BCA
ASSESSMENT REPORT

PROJECT:	46-52 Court Road Fairfield NSW 2165
STAGE:	Development Application Phase
REFERENCE:	25002.2-BCA
DATE:	5 February 2025
CLIENT:	Fairfield Investments No.1 Pty Ltd

Figure 6.1 – indicative fire wall location/s separating different classifications at the ground floor storey

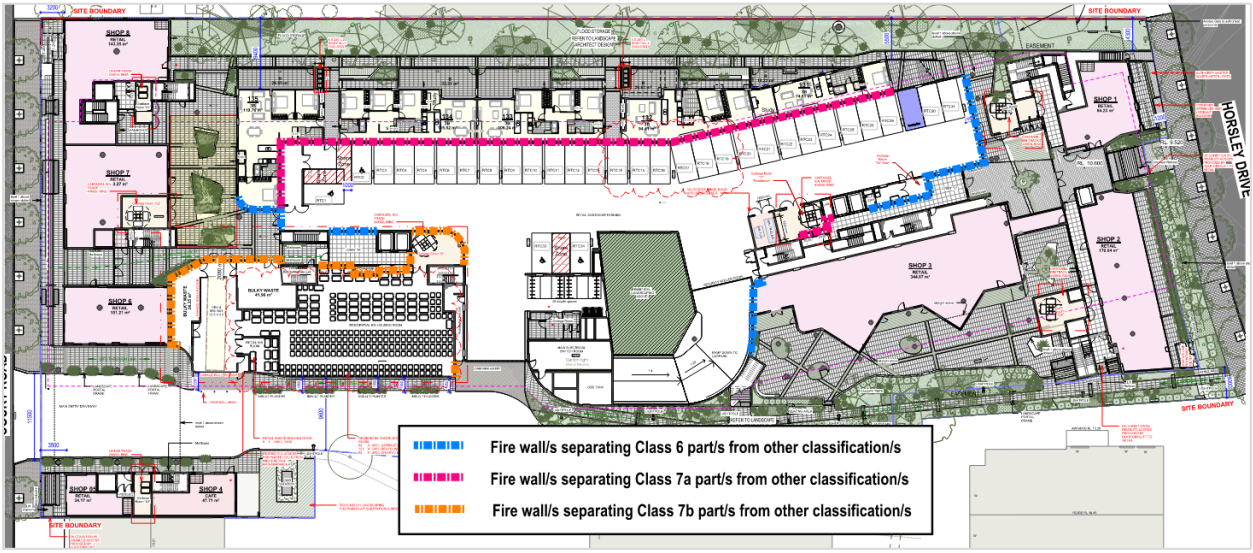
C3D9	Separation of classifications in the same storey	(1) Parts of the building with different classifications located alongside one another in the same storey must have — (a) each building element in that storey having the higher FRL prescribed in Specification 5 for that element for the classifications concerned; or (b) parts separated in that storey by a fire wall. (2) A fire wall required by (1)(b) must have the higher FRL prescribed in accordance with Specification 5 as applicable for that element and the classifications concerned. Refer figures below for indicative locations of fire walls separating different classifications, at the ground floor storey.	CRA

Figure 6.2 – Level 1 floor plan

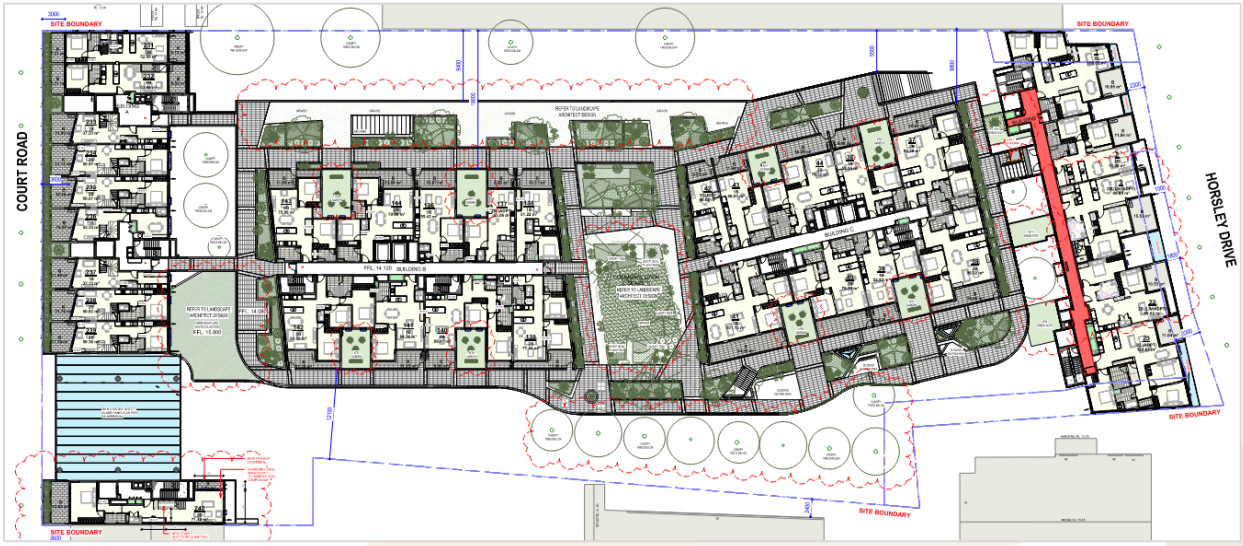
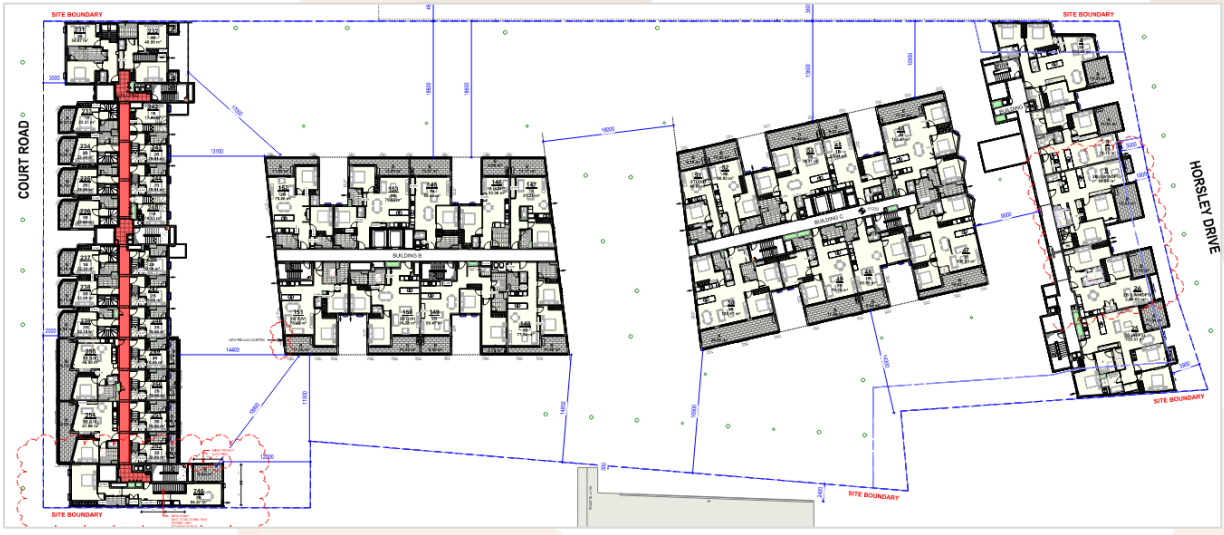
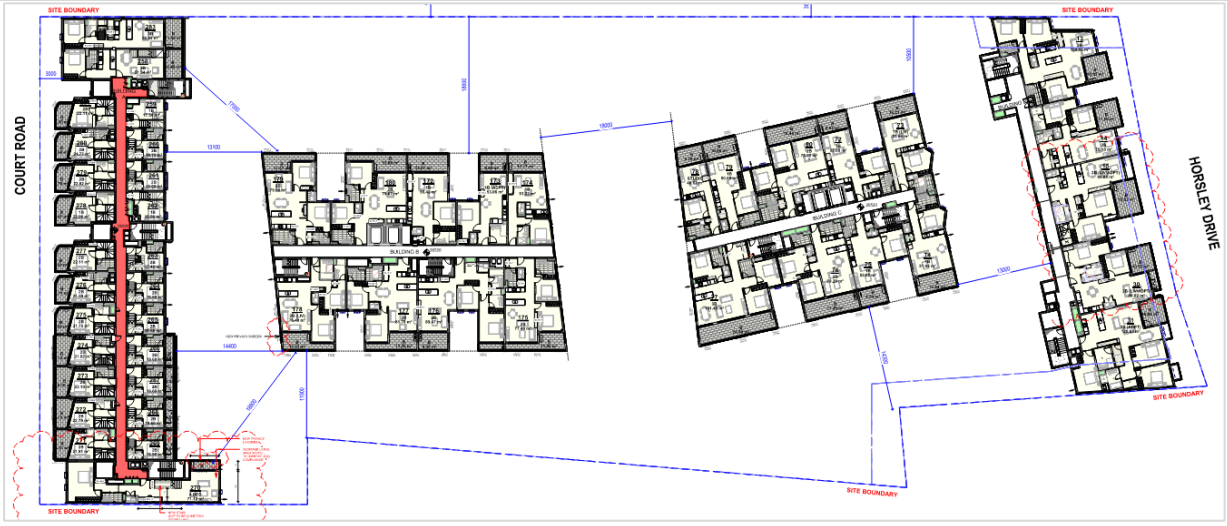
Part C3 – Compartmentation and separation			
BCA Clause		**Comment/s**	**Status**
C3D15	Public corridors in Class 2 and 3 buildings	The public corridors at the following locations are identified as exceeding 40m in length and not provided with smoke proof walls at intervals not exceeding 40m – (a) Level 1 – Level 8 public corridor of Building D; (b) Level 2 public corridor of Building A; (c) Level 5 public corridor of Building A. Notwithstanding the above, a public corridor, if more than 40 m in length, must be divided at intervals of not more than 40 m with smoke-proof walls complying with S11C2.	DNC / PPS

Figure 6.5 – Ground floor plan with openings between columns highlighted

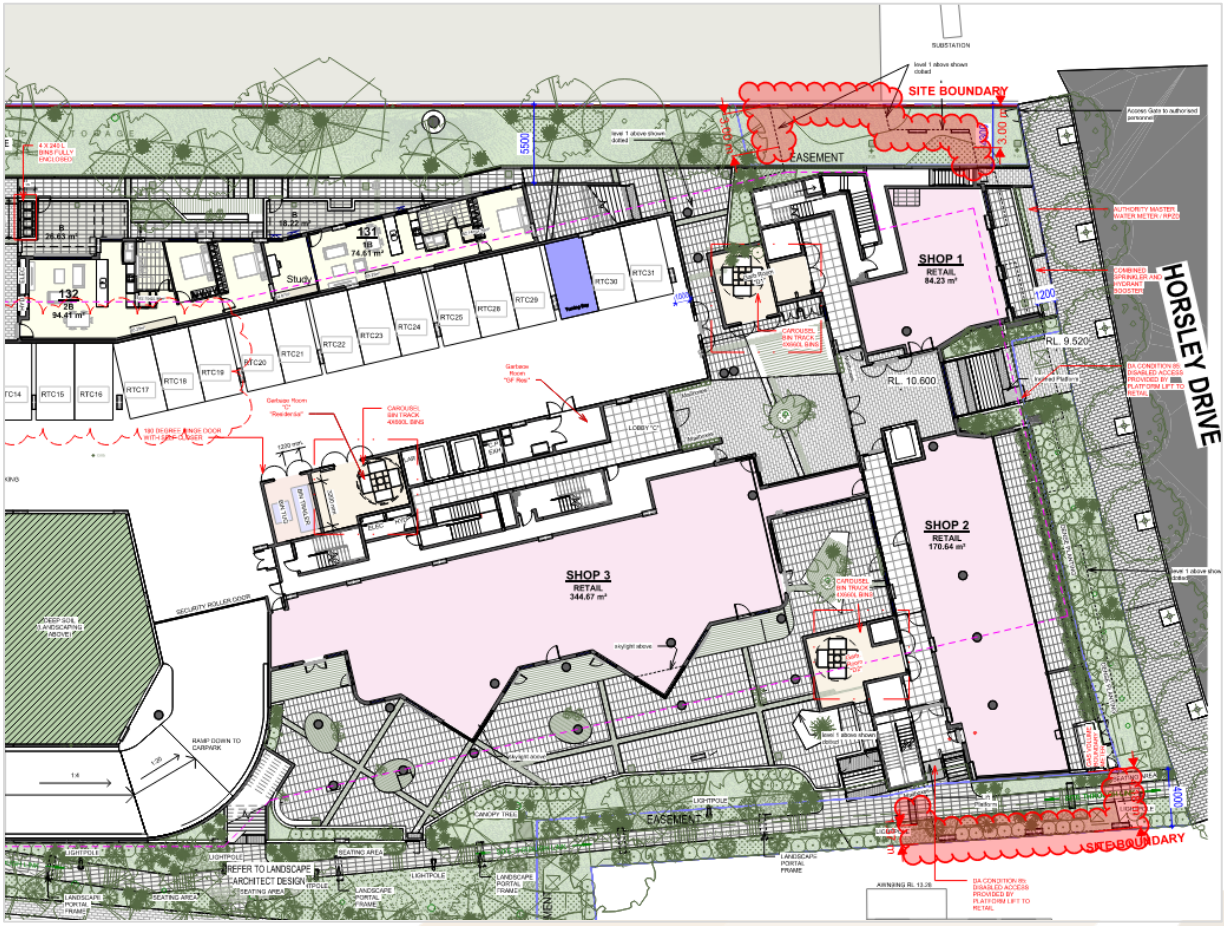
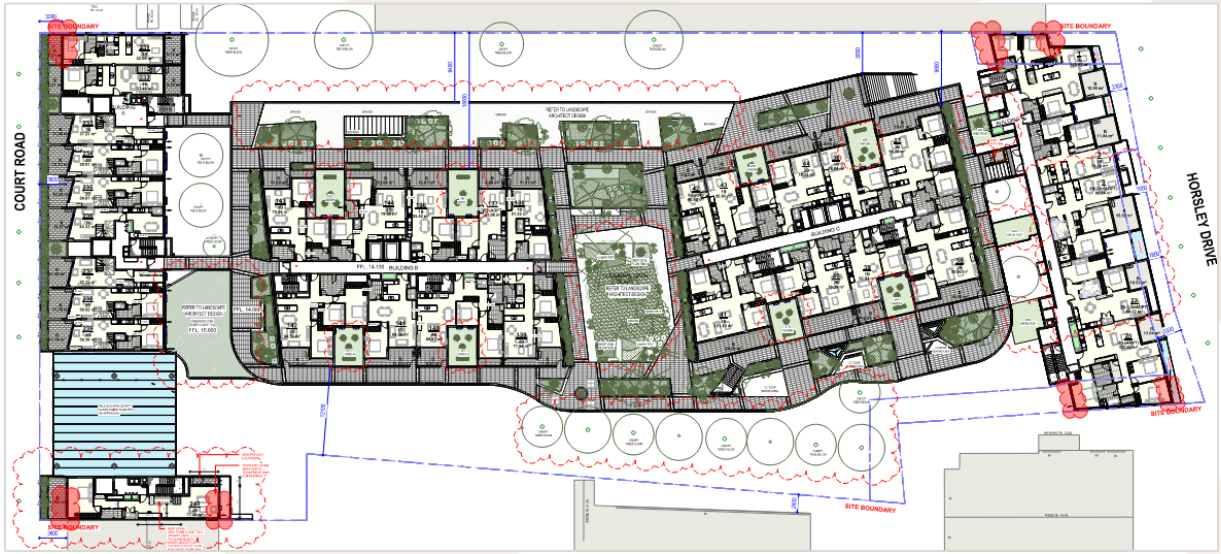
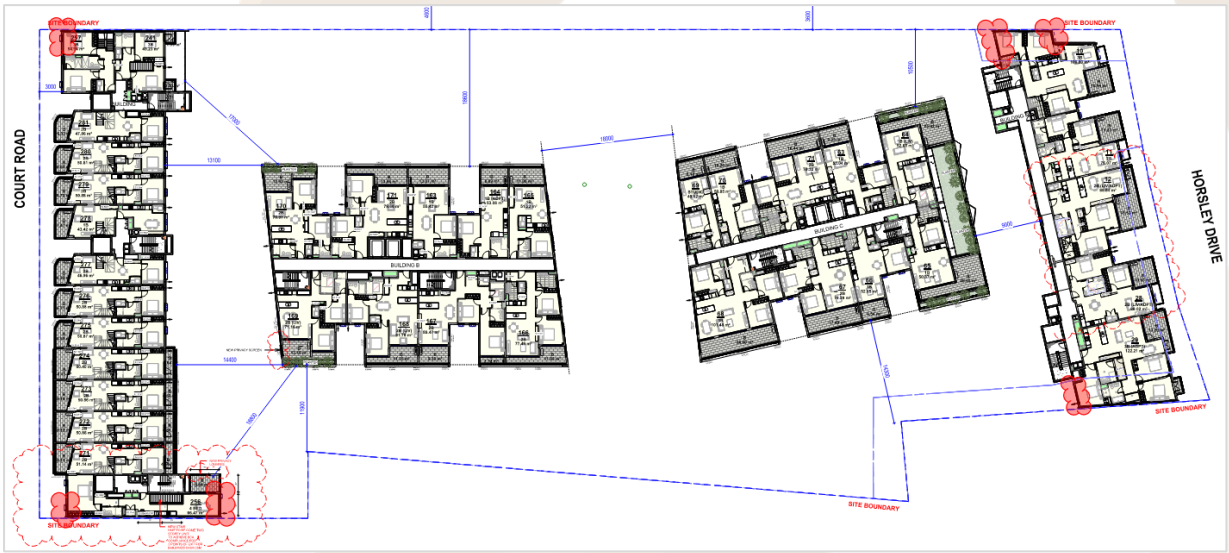
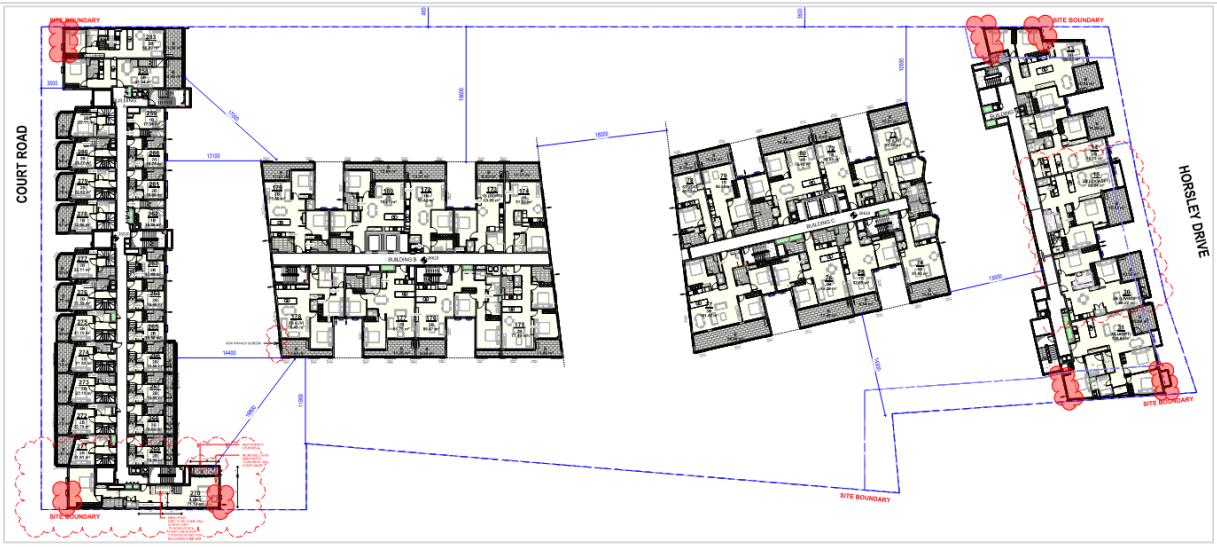
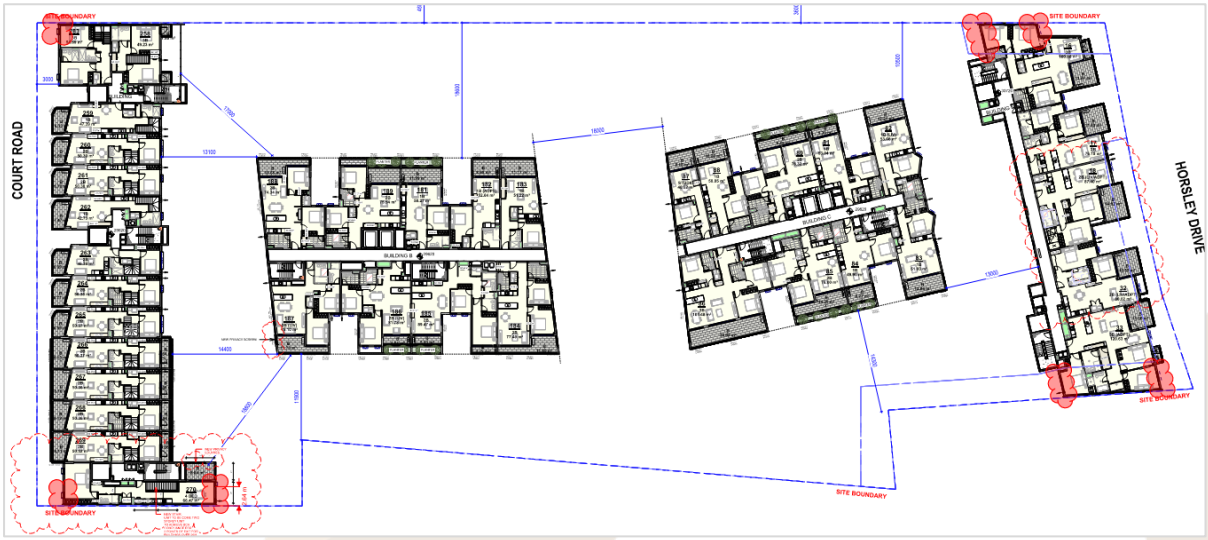
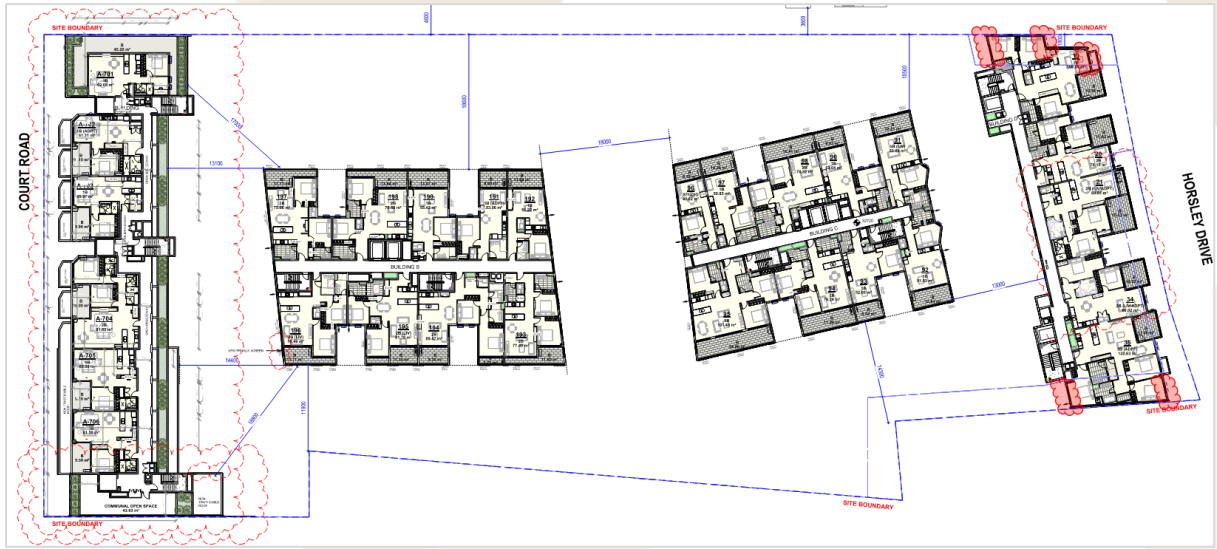
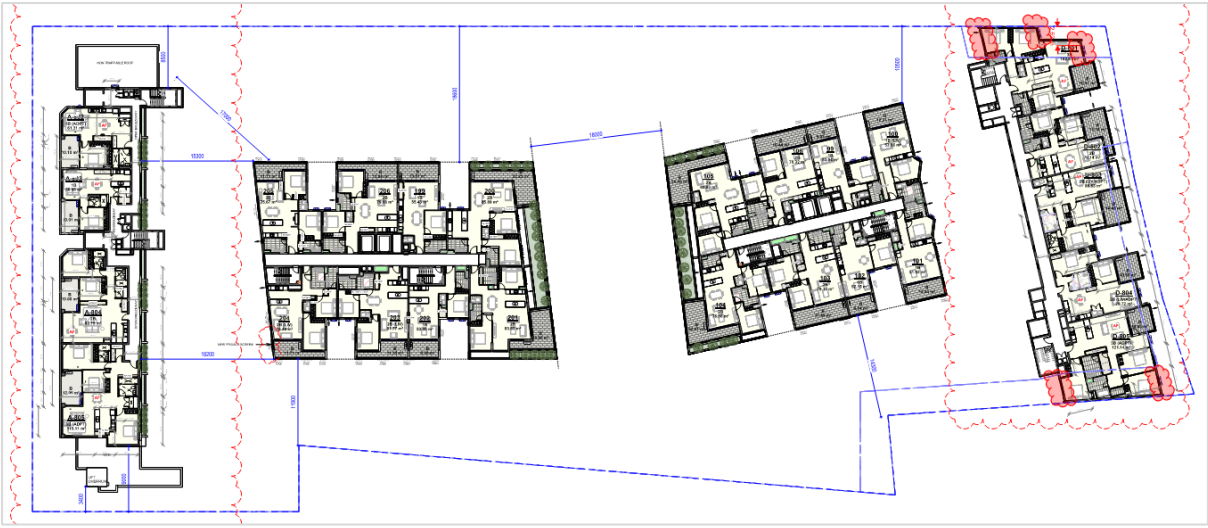
Part C4 – Protection of openings			
BCA Clause		**Comment/s**	**Status**
C4D3	Protection of openings in external walls	Openings in external walls of the building required to achieve an FRL as well as openings formed between columns and the like, in the plane formed at the construction edge of the building, are identified as being located less than 3m from a side allotment boundary and hence must be protected in accordance with C4D5. Refer figures below for locations of openings identified.	CRA / PPS

Figure 6.14 – External walls and openings in different fire compartments

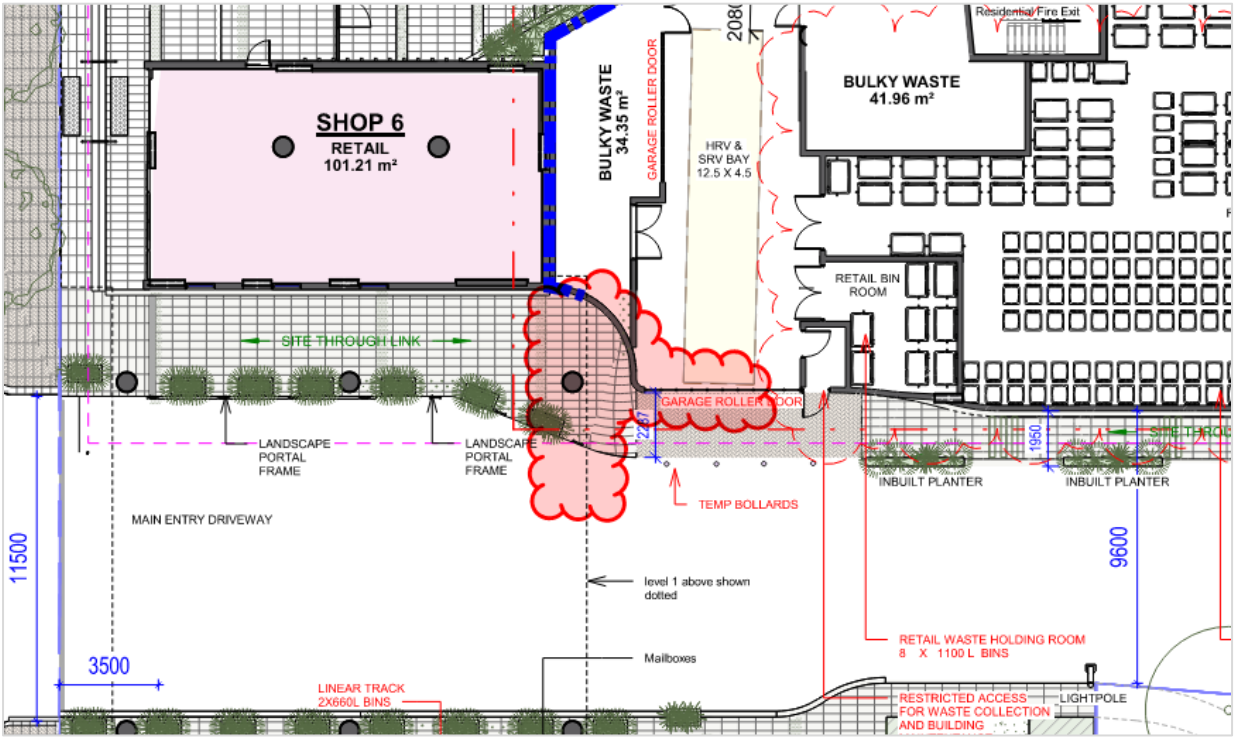
Part C4 – Protection of openings			
BCA Clause		**Comment/s**	**Status**
C4D4	Separation of external walls and associated openings in different fire compartments	It is identified that external walls and openings within them as well as openings between columns and the like, in the plane formed at the perimeter edge of the building, located in different fire compartments between the Class 7b part and the Class 6 parts on the ground floor are less than the distance set out in Table C4D4 of the BCA. Notwithstanding the above, the distance between parts of external walls and any openings within them in different fire compartments separated by a fire wall must not be less than that set out in Table C4D4, unless— (a) those parts of each wall have an FRL not less than 60/60/60; and (b) any openings are protected in accordance with C4D5.	DNC / PPS

Figure 6.15 – Required non-fire isolated stairways serving level 1

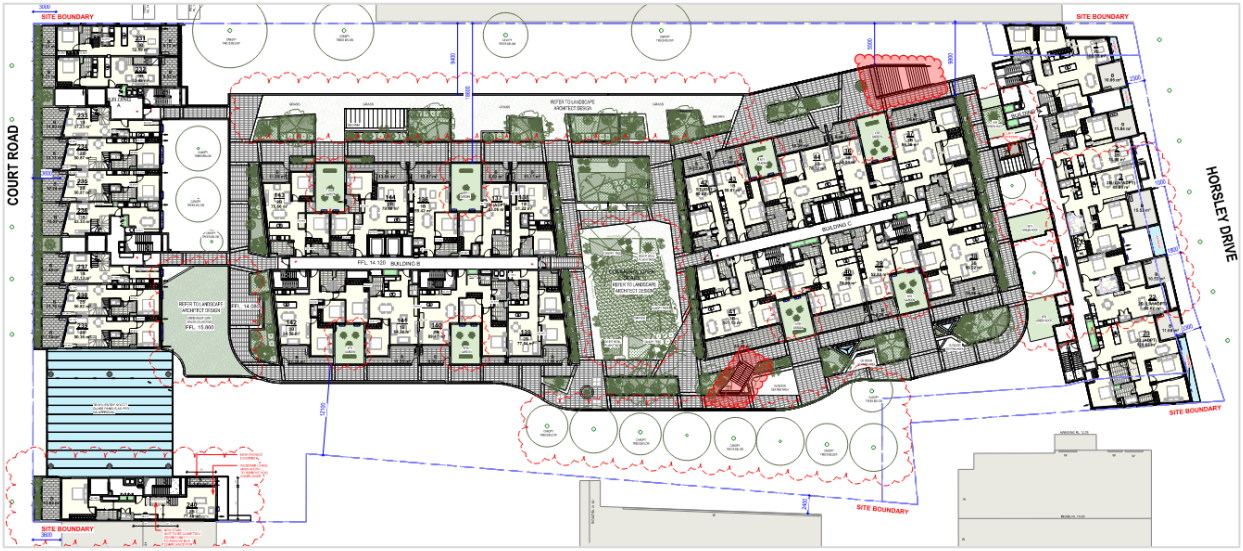
D2D4	When fire isolated stairways and ramps are required	The required stairways throughout the building (excluding the stairways highlighted in the figure below that connect level 1 to the ground floor) have been assessed as fire isolated. The required stairways highlighted in the figure below, connecting level 1 to the ground floor have been assessed as non-fire isolated.	Note
